Document entitled “9pepys3”:
‘Rear Elevation’ diagram amended as indicated

Document entitled “9pepys4”:
‘Second floor plan’ diagram amended as indicated

Document entitled “9pepys5”:
‘Roof plan as proposed’ diagram amended as indicated

Rear Elevation 1:100

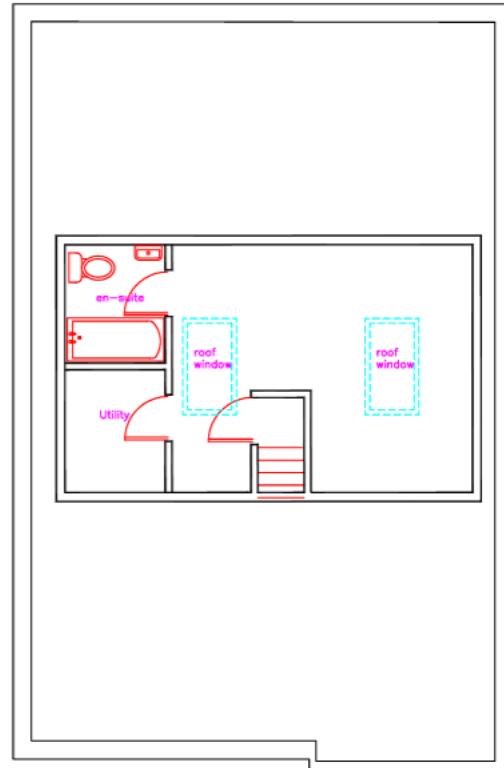
Add new windows in the rear pitched roof. Conservation roof windows to be used.

Second floor plan 1:100

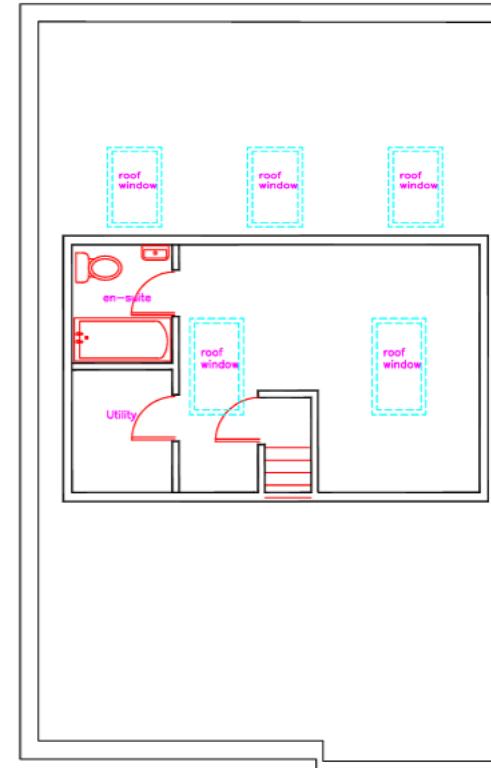
Add new windows in the rear pitched roof, and one or both roof windows on the flat roof to be removed.

Roof plan 1:100 as proposed

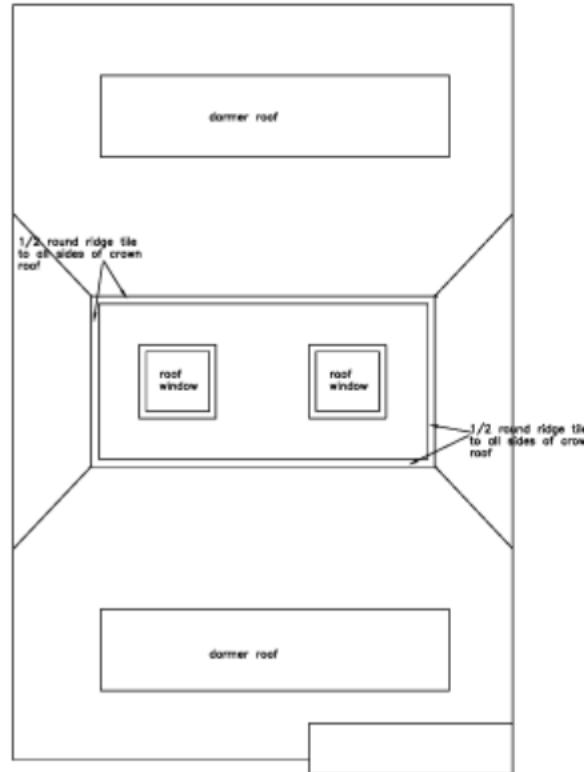
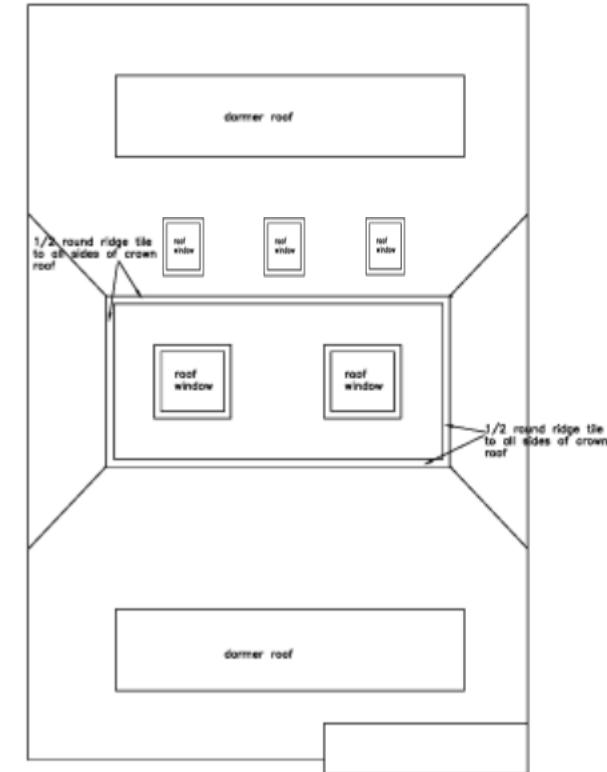
Add new windows in the rear pitched roof, and one or both roof windows on the flat roof to be removed.
